Each option has been given a rating of good (L), neutral (M) or poor (H) for each of these criteria as shown in Table 12. - **Revise to numeric scoring 1-poor, 2- neutral, 3- good**

Please find attached an objective link to the *Red Hill Reserve Surrounds Strategic Traffic Study* revised draft report for your review and comment.

Figure 26: PT and Active Travel Facilities

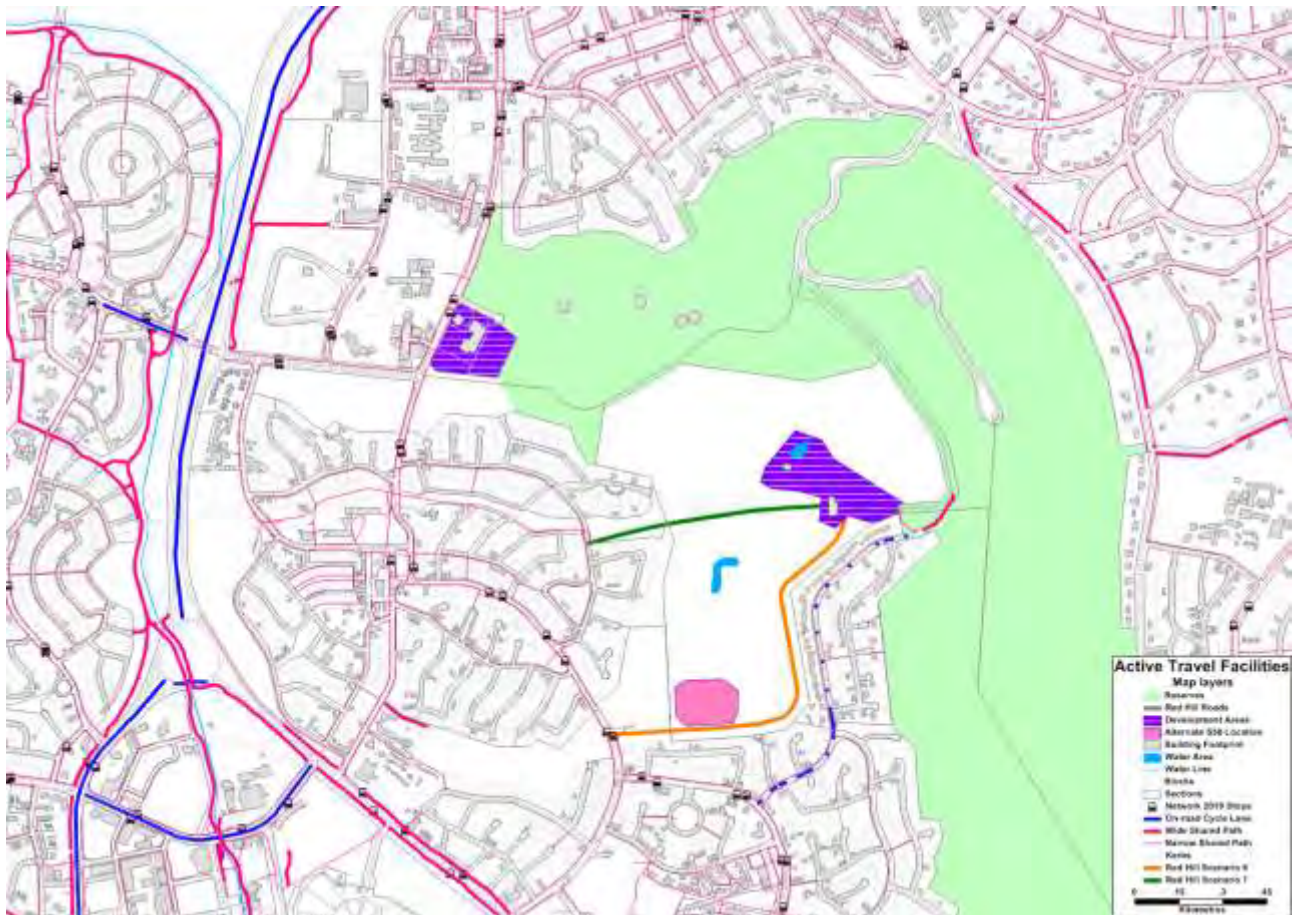
Having said that I have looked at the report and suggested amendments. The figures will need to be updated to reflect the Kitchener Street 'short' option. This is particularly important for Figure 26 in which public transport and active travel are assessed.
